(A)

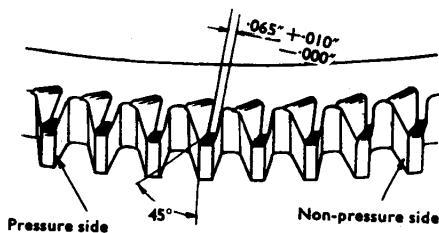
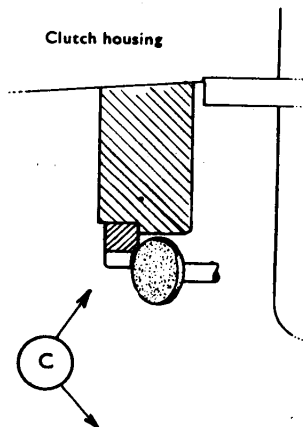
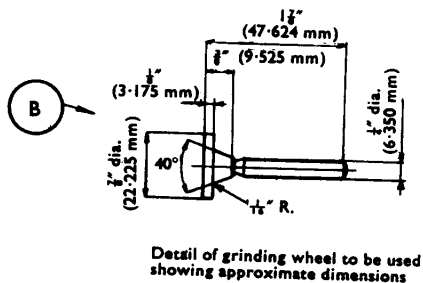
grinding the flywheel ring gear as shown at (C). This operation may be carried out on Javelin and Jupiter models with the engine in position using a grinding wheel of the dimensions shown at (B). The new type ring gear is fully interchangeable with the previous type and the fitting instructions remain the same.
